WATERS Weekly FPY review (WW29 – 2018)

25 Jul 2018

WAT-441001280 (Ethernet Cable, supplier CMTi)

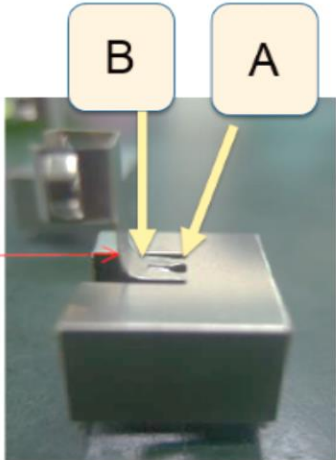
Description	Owner	To complete by	Status
2) Ethernet Cable (PN 441001280) – reopen this issue • Background: WW52 – one cable found damaged and failed Final Test. • Proposal for improvement from CMTI – refer to next slides. • 01 May: To jointly review if to go ahead with this proposal. • 23 May: CMTi to provide samples. • 04 Jul: 2 x samples received. To put up a PCN to WPPL for review.	Flex	TBA	Open

A – current bending point
B – proposed bending point

WAT-441001280 (Ethernet Cable, supplier CMTi)

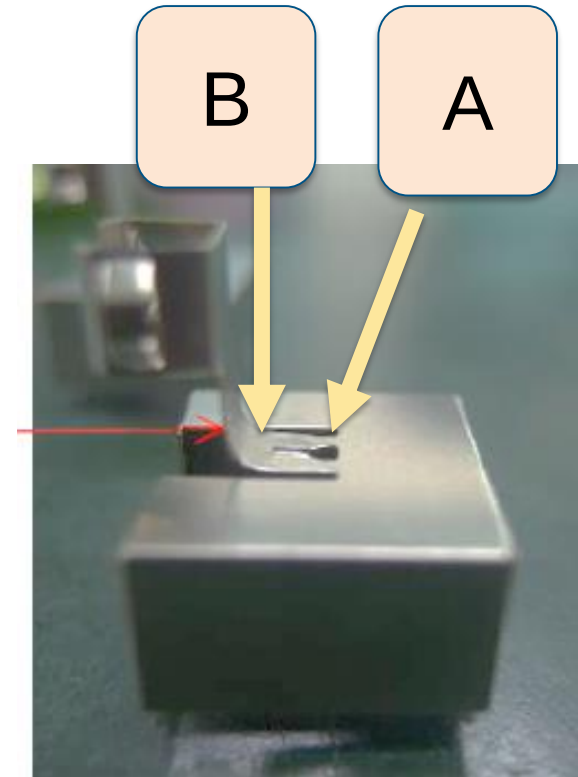
- CMTi reported that there is no failure reported at their outgoing since May 2017 (Qty tested: 9200 pcs)
- CMTi proposed to change the bending point.
- See Appendix A for more detail

A – current bending point
B – proposed bending point

- Option A – if we were to proceed with this change, CMTi will have to raise a PCN (Process Change Notice). A small qty for trail is proposed before implementation in mass production.
- Option B – no change is needed. Based on the performance the failure rate is relatively low.

- There is no failure in Feb 2018 and Mar 2018 (Total > 600 instrument build)
- As the occurrence (Ethernet cable failing) is low and random, Flex does not recommend to go ahead with this change (Option A).
- Flex recommends to further monitor the yield and keeping this proposal as an option for future discussion.

Current bend method

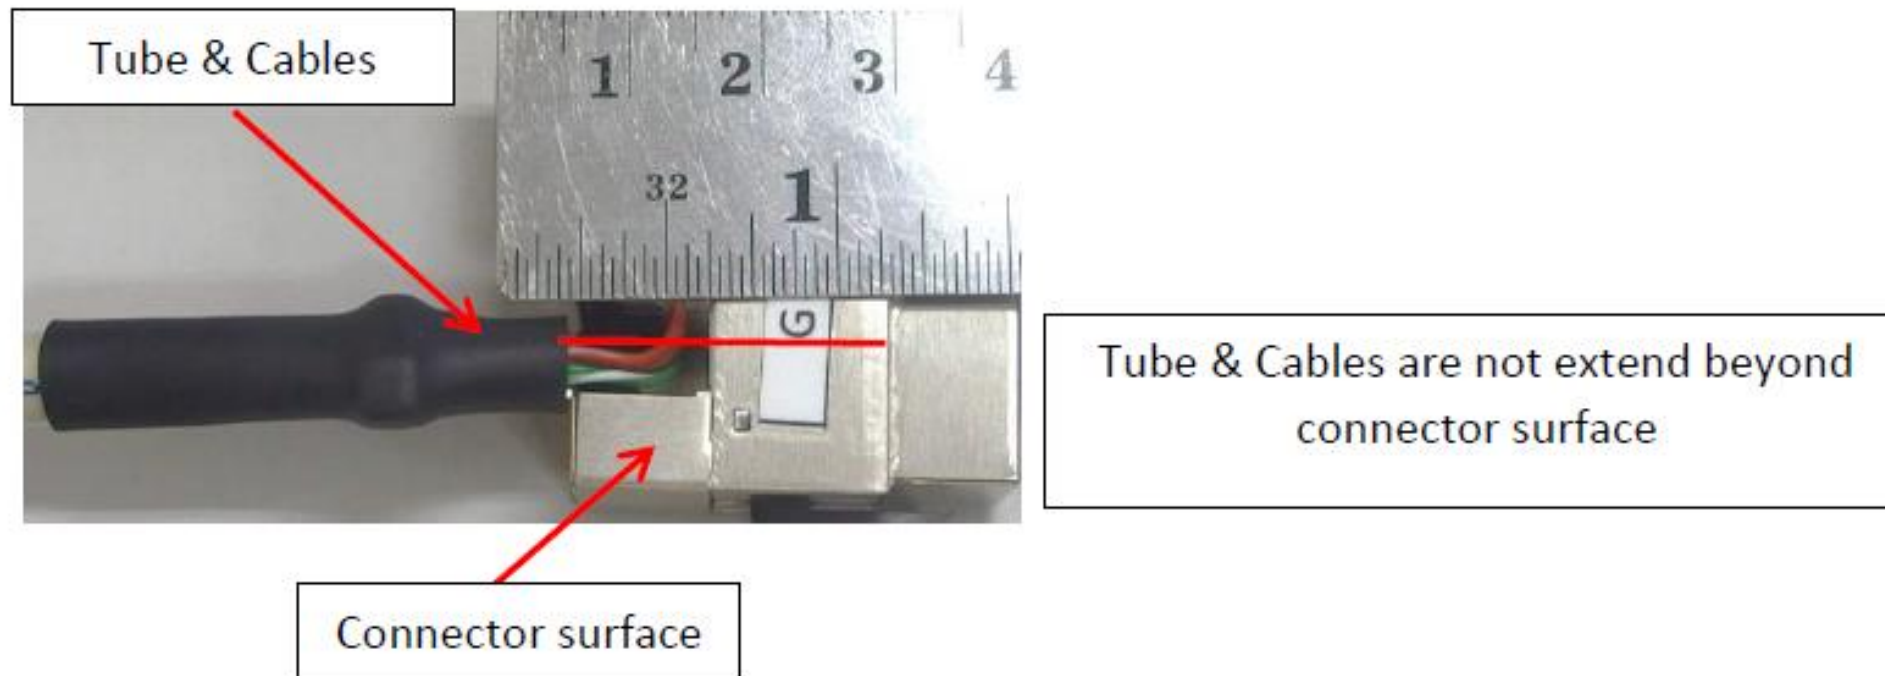
- ✓ Current bending method : Connector broken after 22 times bending
- ✓ Propose bending Method : Connector broken after 64 times bending

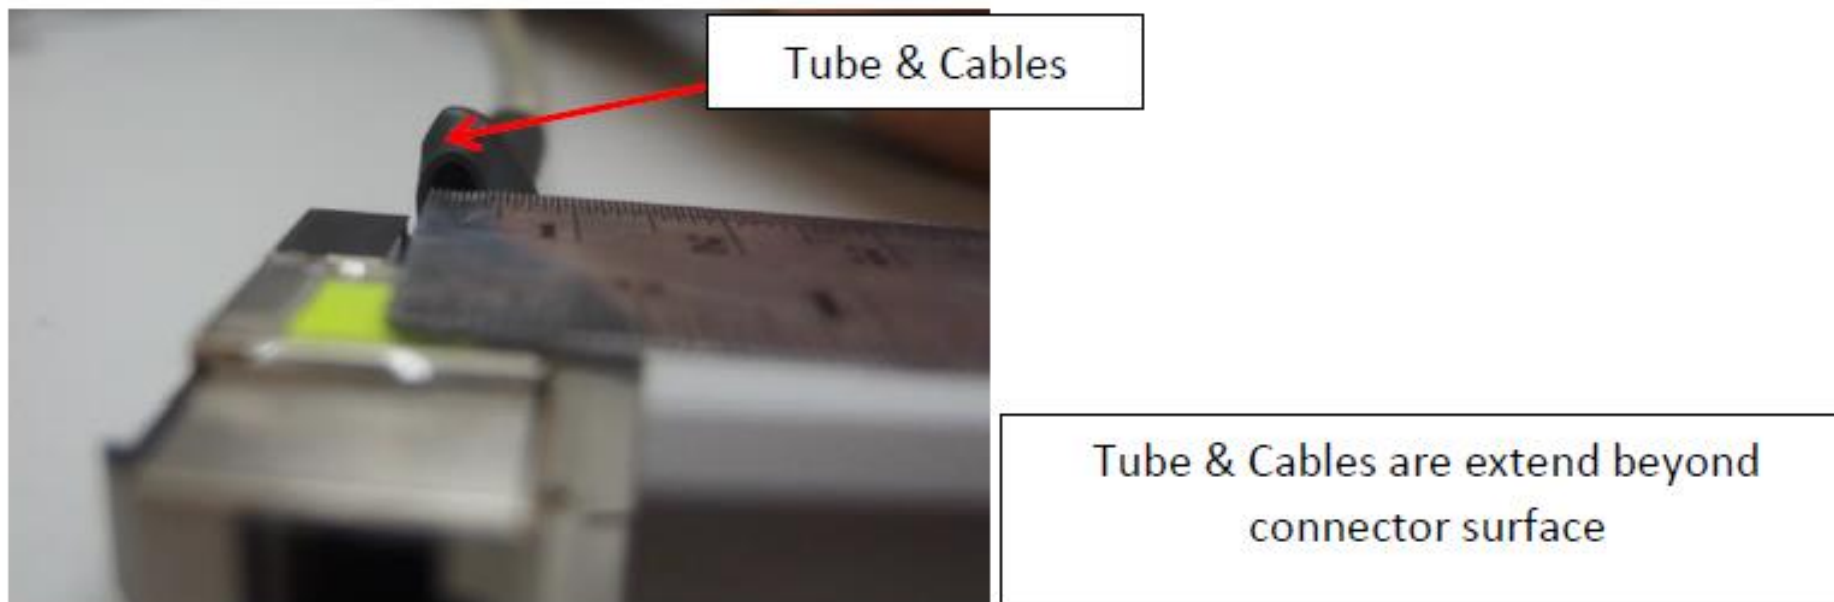
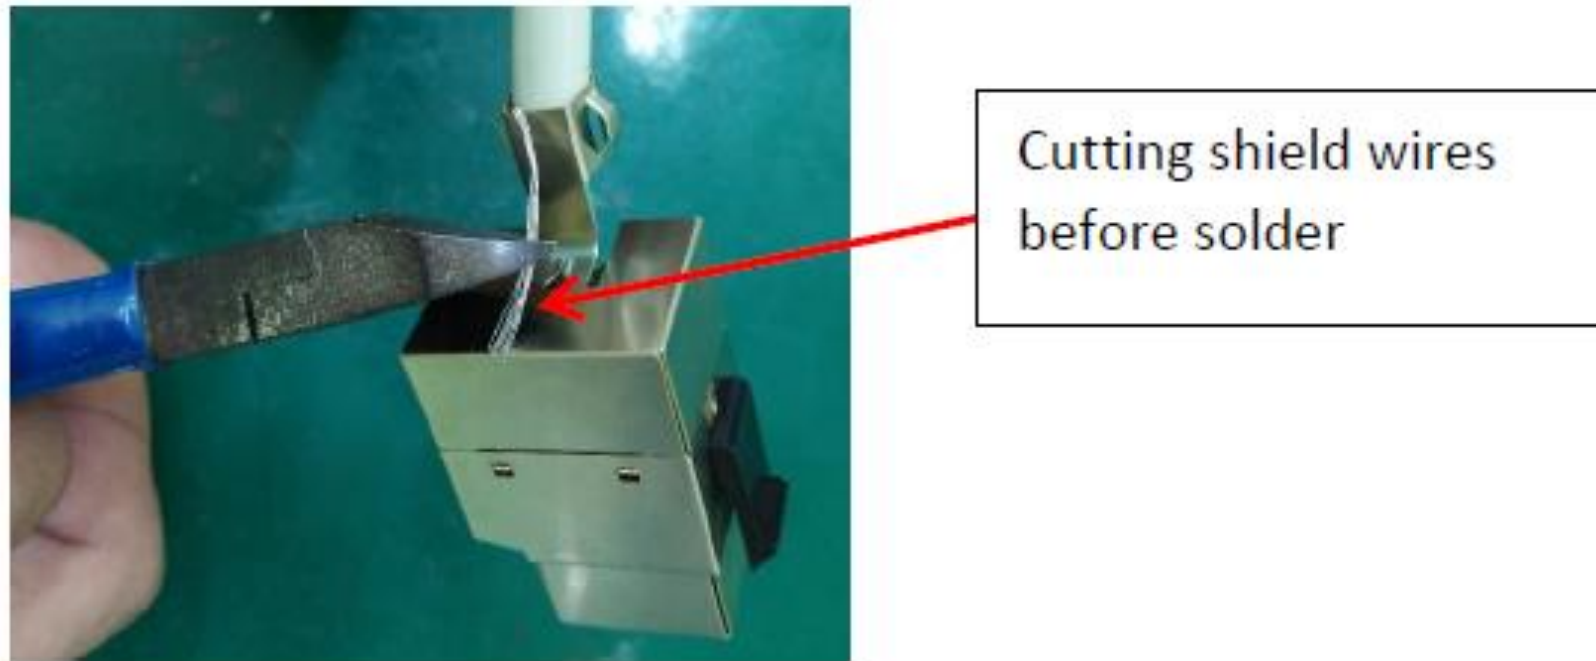
1. Propose bending method strength result is better than current bending method
2. Cable position of propose bending method is out of connector surface (refer to below picture for comparison)

3. There's additional cutting process for shield wire before solder to metal shield

4. Total Length of cables might sorter than current bending method. Therefore, we will conduct another simulation with actual product requirements when it's required.

- Propose bending method strength result is better than current bend method
- Cables & tube position are extend beyond connector surface might effect to form, fit
- There has additional cutting process for shield wire before solder
- Next simulation for total length of cables shall study if it's required.

Seal Pack Assembly 4M Review

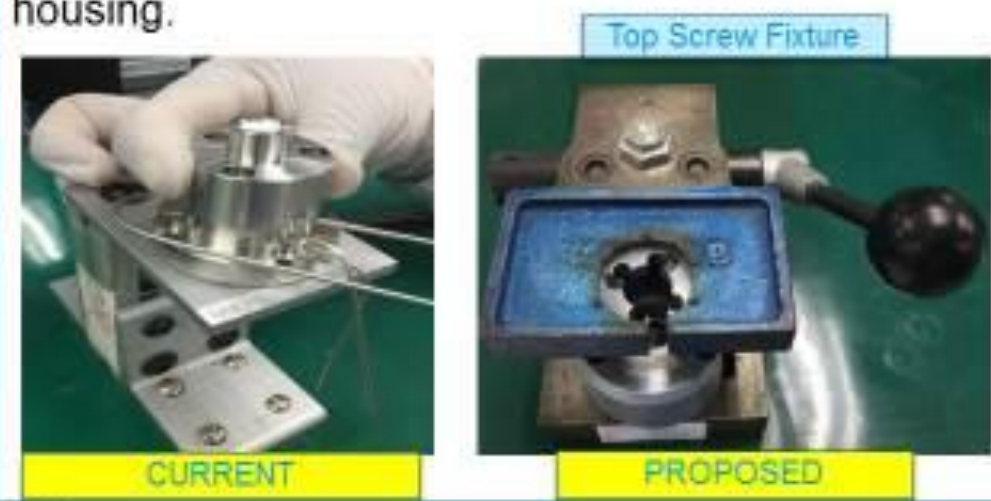
Category	Possible Causes	Verification	Possible cause (Y/ N)	Proposed Actions
Man	1) Untrained/ Uncertified operator	Verified trained/ certified operators are performing Sub Assy and Injector Test. No change in people observed.	N	NA

2) Operators not following the MPI defined steps.	Verified that operators performing the tasks as per Work instructions. No abnormality found.	N	NA
Method	Assembly method not repeatable and inconsistent	1)Assembly methods like Press operation, chemical wetting, screw tightening processes were reviewed and found ok. 2)It was suggested to put few more drops of methanol during press operation in-addition to current wetting of seals with methanol	N	Briefed Operator to pour methanol during both press operations in-addition current methanol wetting to seals.
Machine	No manufacturing Aids/Fixtures/Jigs.	1)Press fixtures were ok and no abnormality found. 2)Current Holding Fixture 999044874 does not allow to hold and press down Top, Middle and Bottle housing assembly into holding fixture before screwing assembly.	Y	Propose to purchase new fixture with top cover plate to hold and press down the Top, middle and bottom housing.  Top Screw Fixture CURRENT PROPOSED
